BELL BEND NUCLEAR POWER PLANT
RESPONSE TO ENVIRONMENTAL
REQUESTS FOR ADDITIONAL
INFORMATION, SEVENTH
SUBMITTAL
BNP-2009-342 Docket No. 52-039

Responses to Environmental Requests for Additional Information
Bell Bend Nuclear Power Plant
Luzerne County Pennsylvania

Revised Figure 2.4-10 {Susquehanna River Bathymetry near Intake & Blowdown Structures}

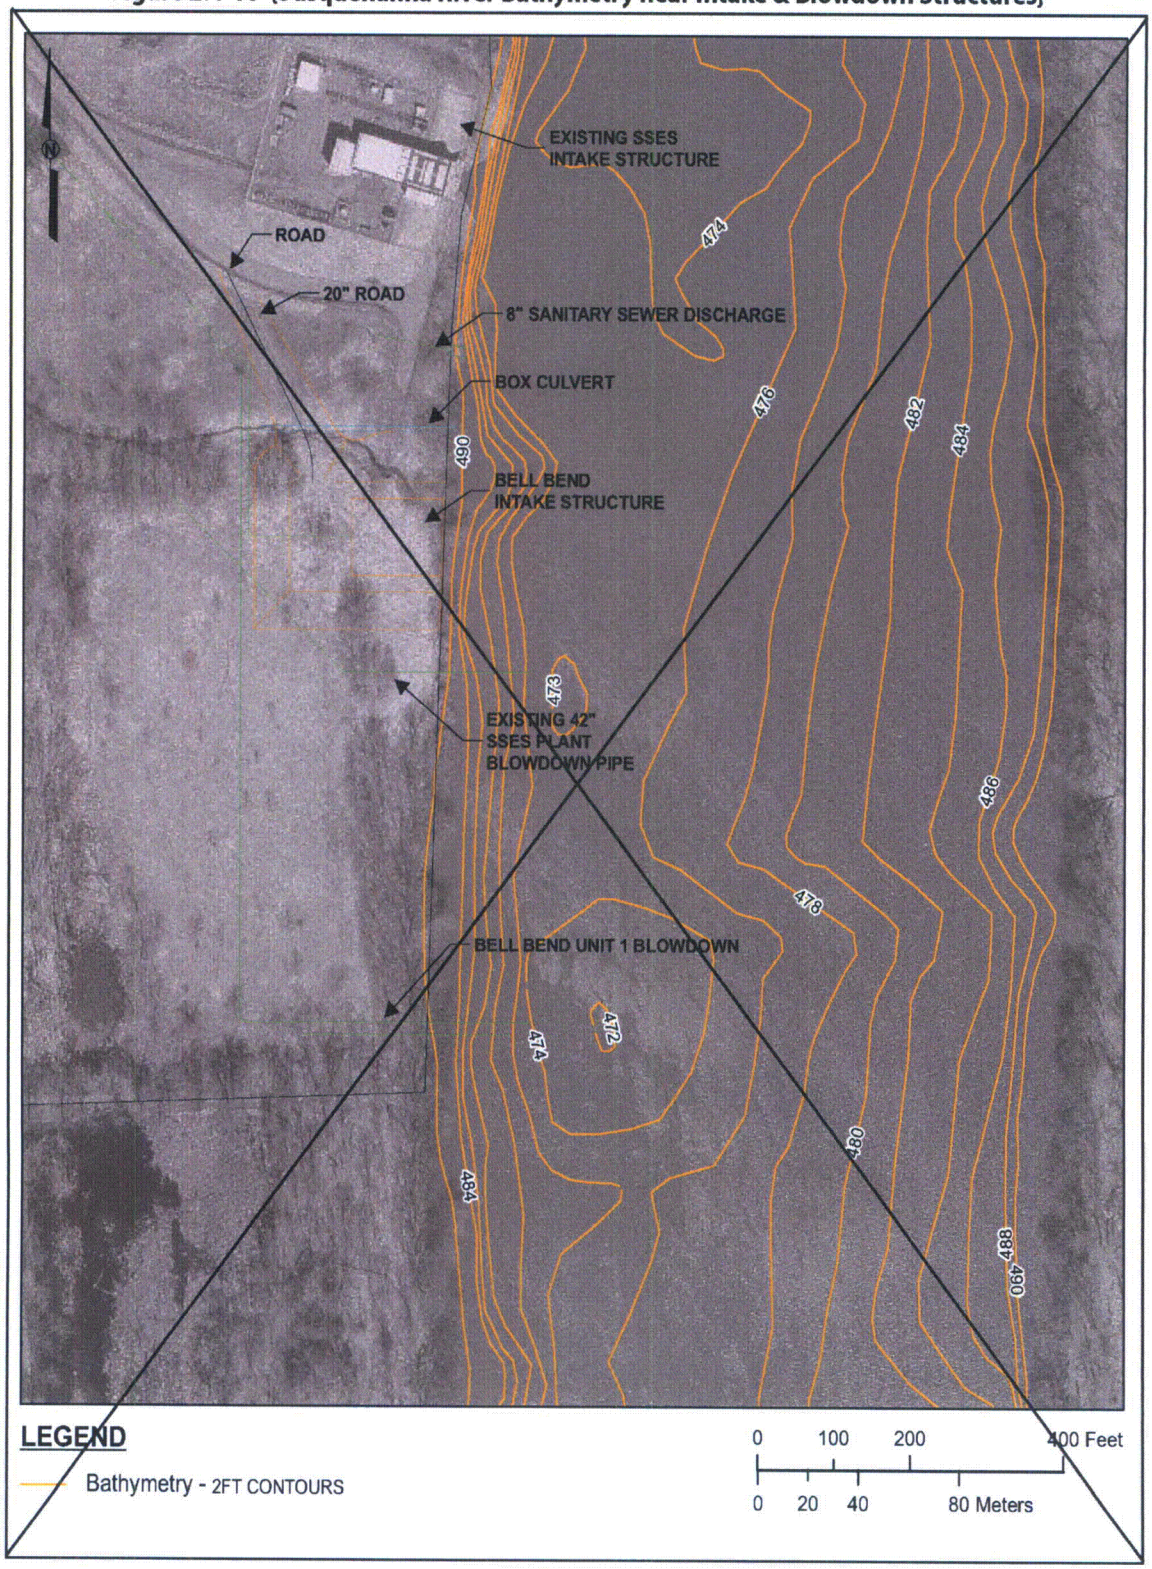
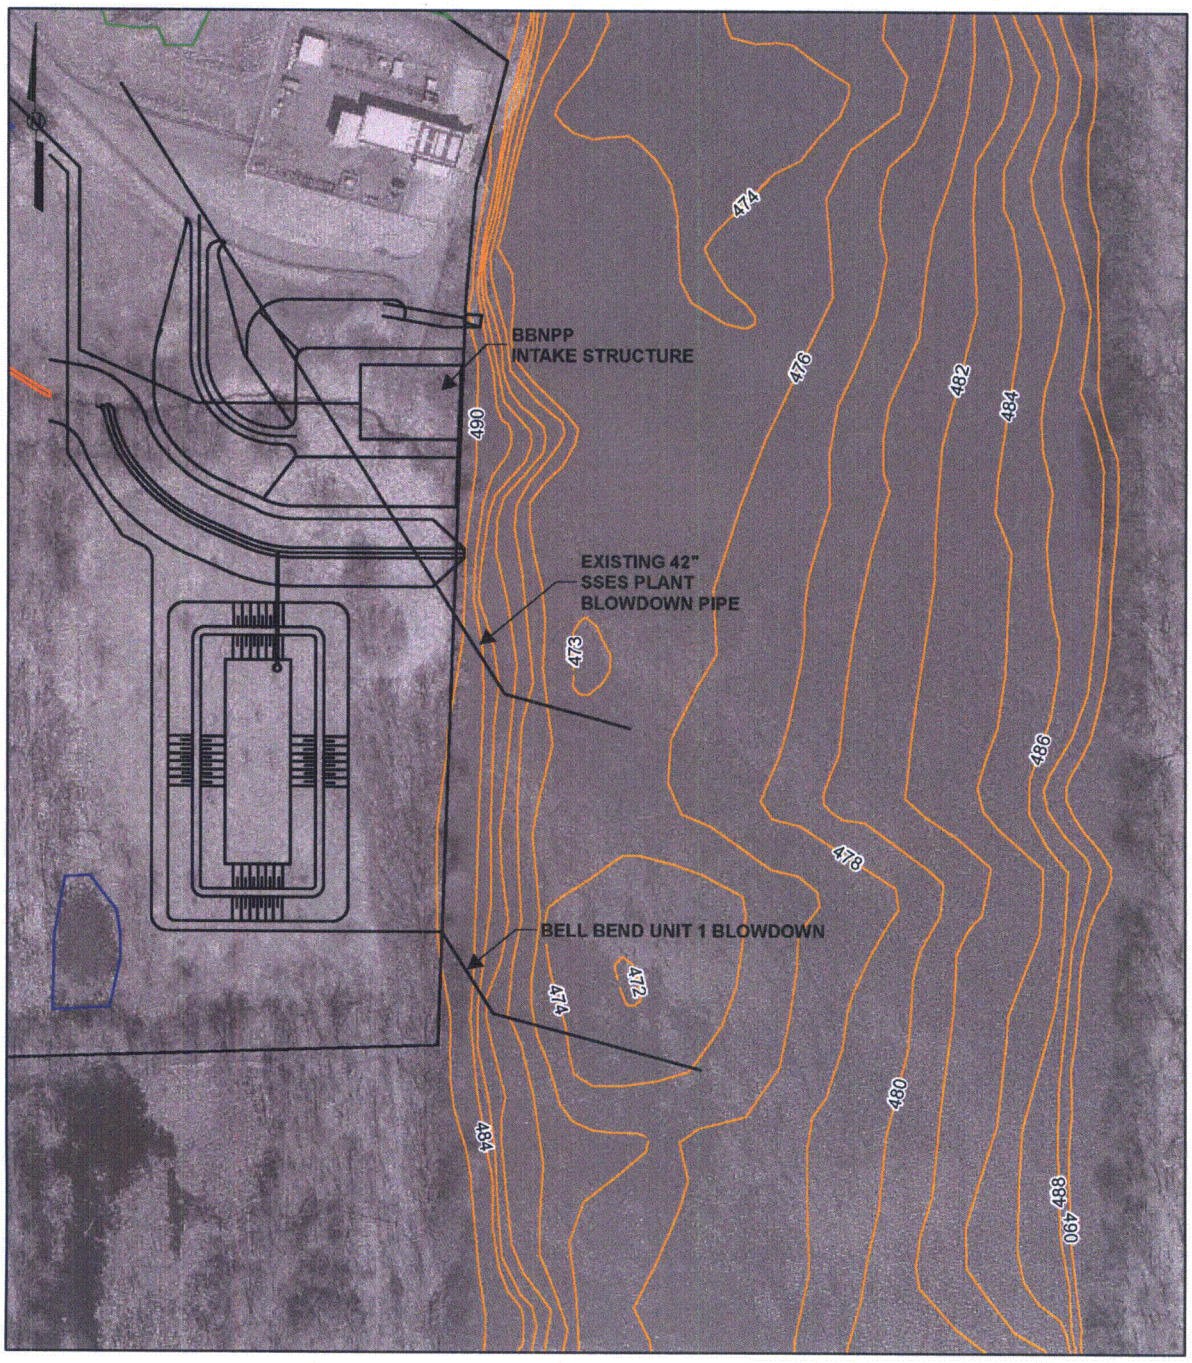
Full Text: There are various discussions in the ER text that indicate different lengths for the discharge pipe. The text (Ch. 3) describes the cooling system discharge pipe as extending 212 ft from shore with a diffuser that is 106.5 ft long from first port to last with 72 4-in.-diameter ports spaced at 1.5-ft intervals. The text in ER Ch. 5 describes a 120-ft-long diffuser, which would give a total pipe length of 332 ft. The text on ER Rev 1, p. 5-22 describes a 200 ft pipe. Figure 3.4-6 appears to show the diffuser as being only 40.5 ft from first port to last with 28 4-in.-diameter ports spaced at 1.5-ft intervals. Note also that text in aquatic ecology impacts seems to differ (ER Rev 1, p.4-45) but is close to dimensions in ER Chapter 5.

The BBNPP discharge pipe extends approximately ~~200 ft (61 m)~~ 310 ft (95 m) into the Susquehanna River (Figure 2.4-10). As a conservative approach, the probable minimum flow of 532 cfs (15 m^3/s) recorded at Wilkes-Barre was used as the design basis. The flow of 532 cfs (15 m^3/s) will bring the water level near the discharge line to approximately elevation 485.3 ft (147.9 m) msl (Soya, 1991). The CWS Makeup Water Intake Structure Design will accommodate river levels as low as 484 ft (148 m) msl. The centerline of the discharge line is at elevation of 476 ft (145 m) msl, approximately 9 ft (3 m) below the estimated water level near the discharge line and 8 ft (2 m) below the established design low water level for the CWS intake; thus low water levels will not uncover the discharge pipe or affect the non-safety-related makeup water supplies.

Figure 1 – BBNPP Vicinity Map

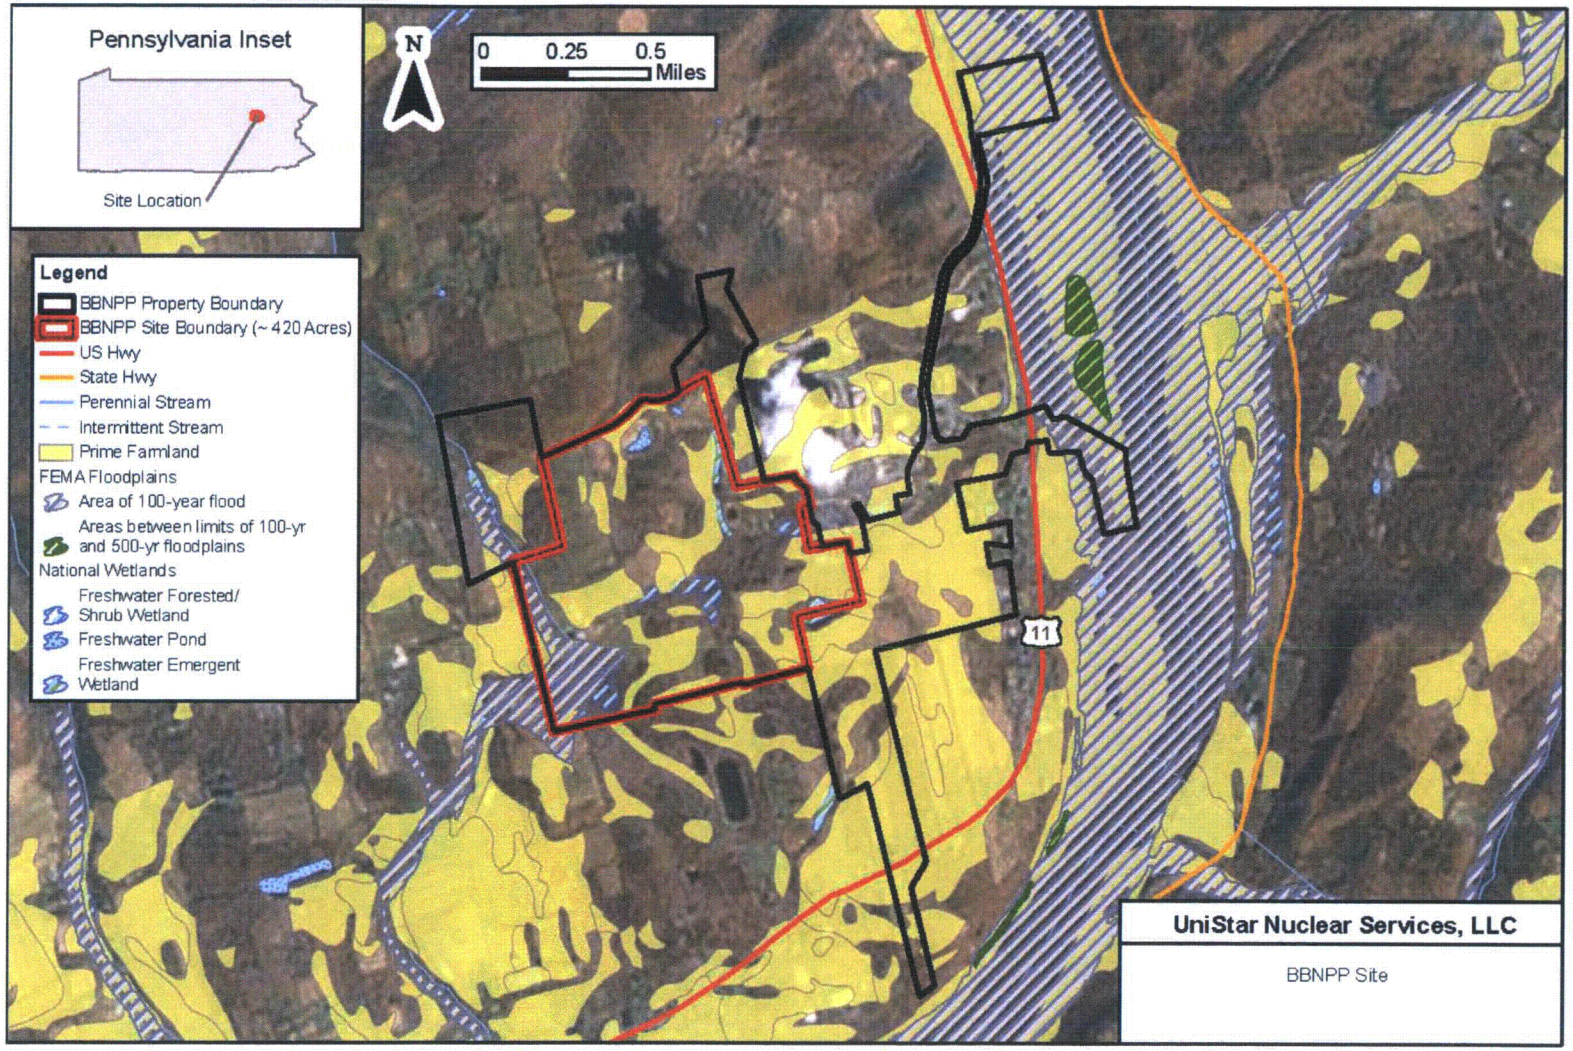
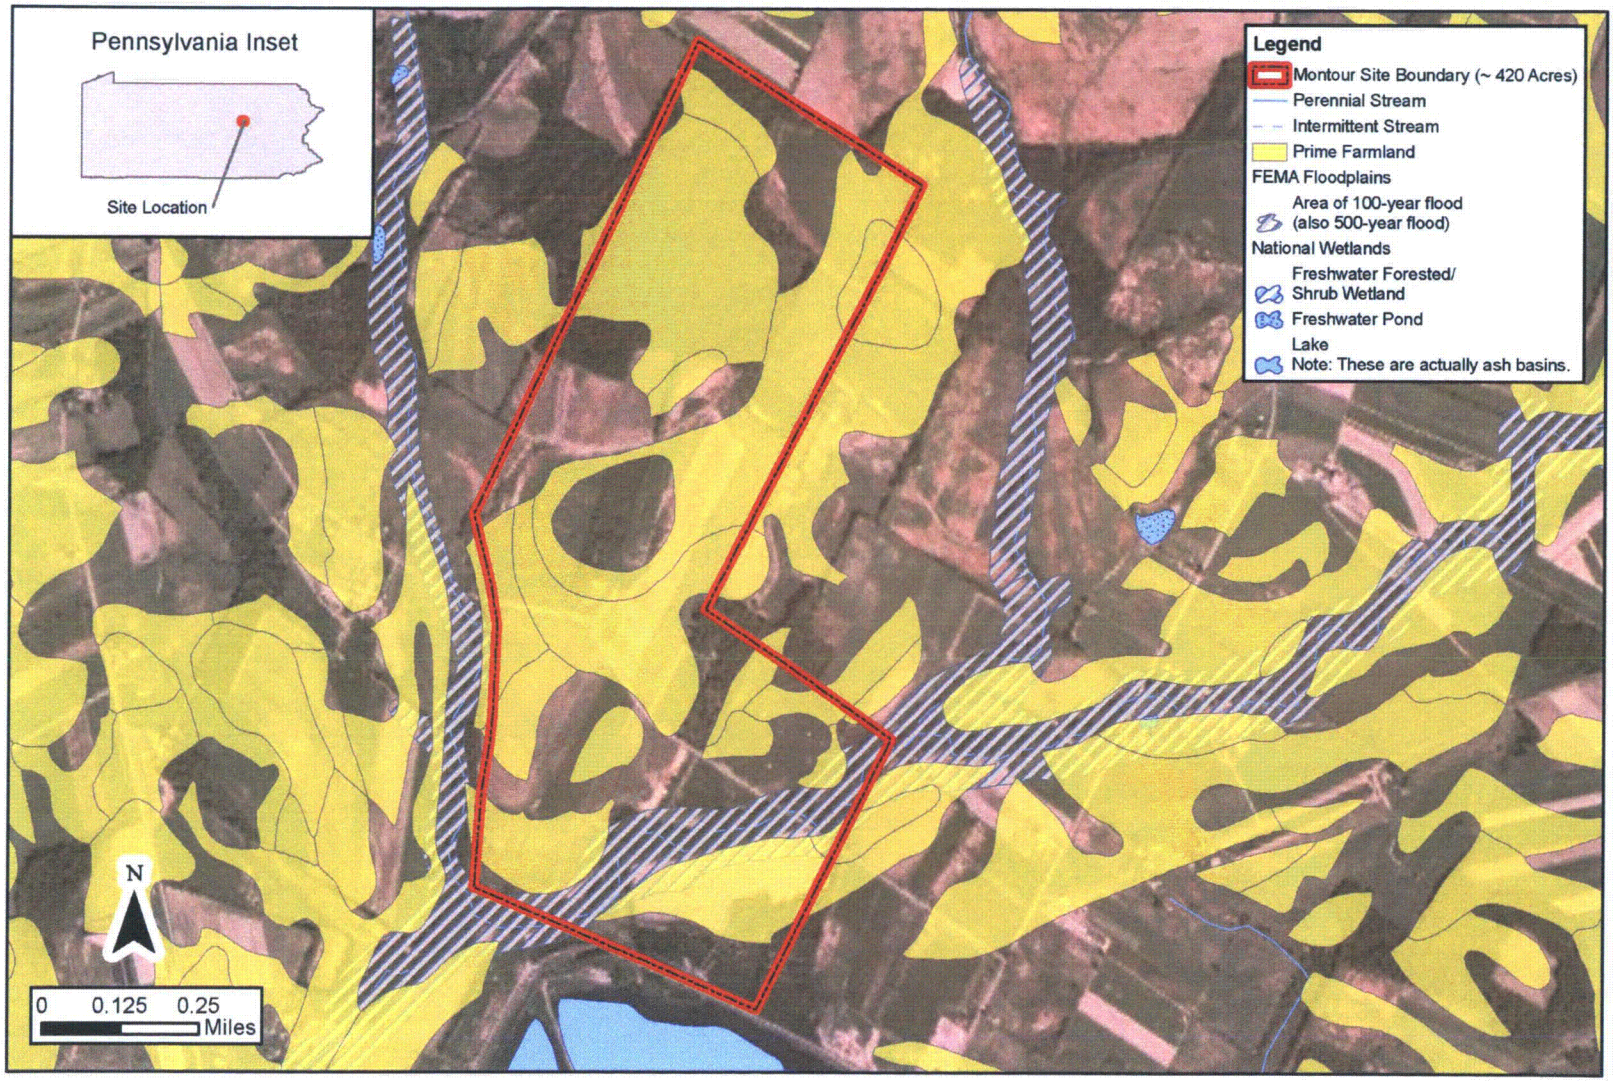
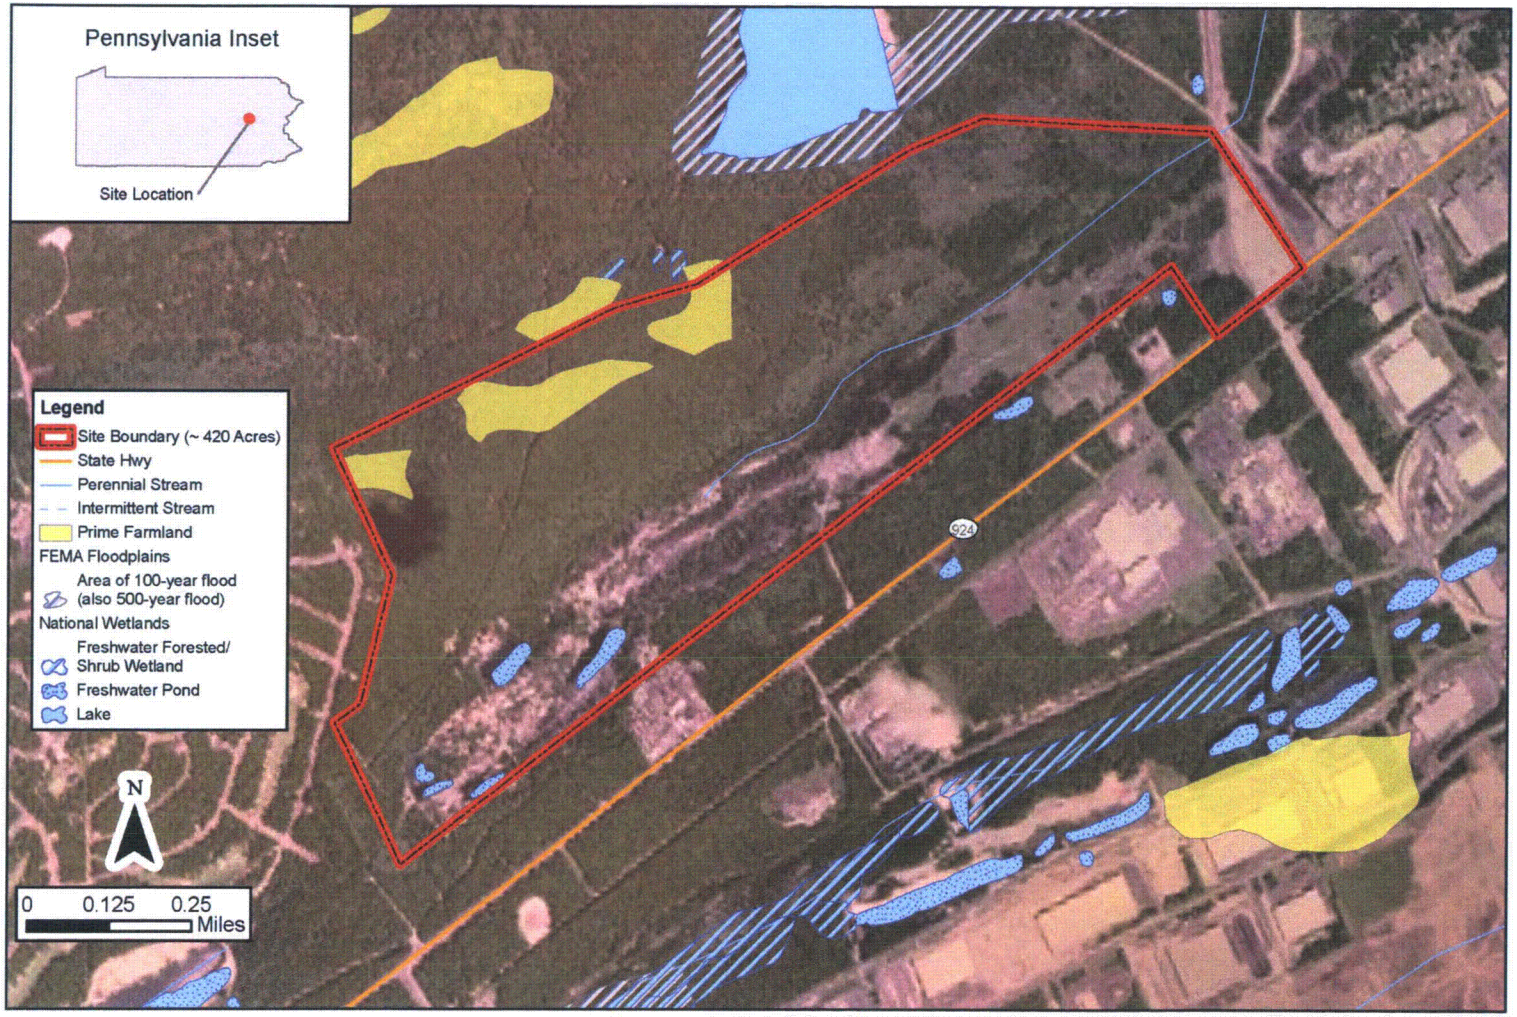
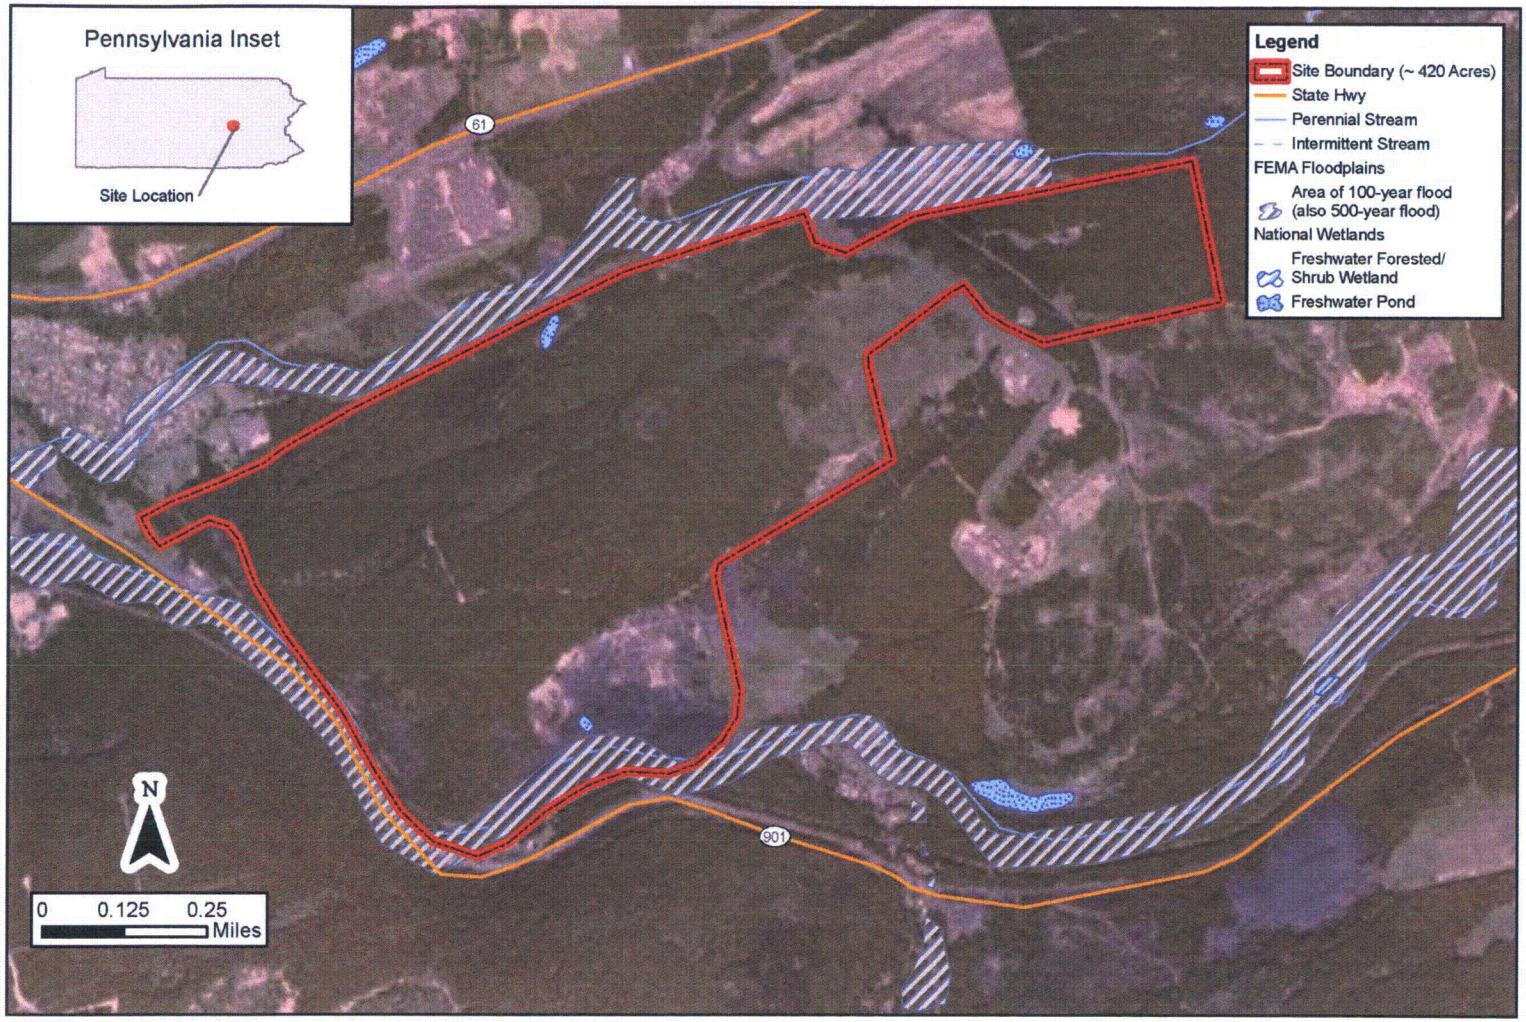
Full Text: Figures 9.3-7, 9.3-9, and 9.3-11 are vicinity maps that show a much larger area than is useful for evaluating potential impacts to aquatic resources.

Response: The alternative site screening process described in Section 9.3 of the ER has been superseded by a revised process (PPL, 2009a). Using the revised process, the entire alternative site evaluation has been repeated. The revised evaluation has resulted in the Sandy Bend and Martins Creek sites being eliminated as alternatives to Bell Bend. The alternative sites discussed in revised Section 9.3 are Montour, Humboldt Industrial Park and Seedco Industrial Park (PPL, 2009b). Vicinity maps showing wetlands and water bodies, floodplains and prime farmland are shown for each site: Figure 1 – BBNPP Vicinity Map, Figure 2 – Montour Site Vicinity Map, Figure 3 – Humboldt Industrial Park Vicinity Map, and Figure 4 – Seedco Industrial Park Vicinity Map.
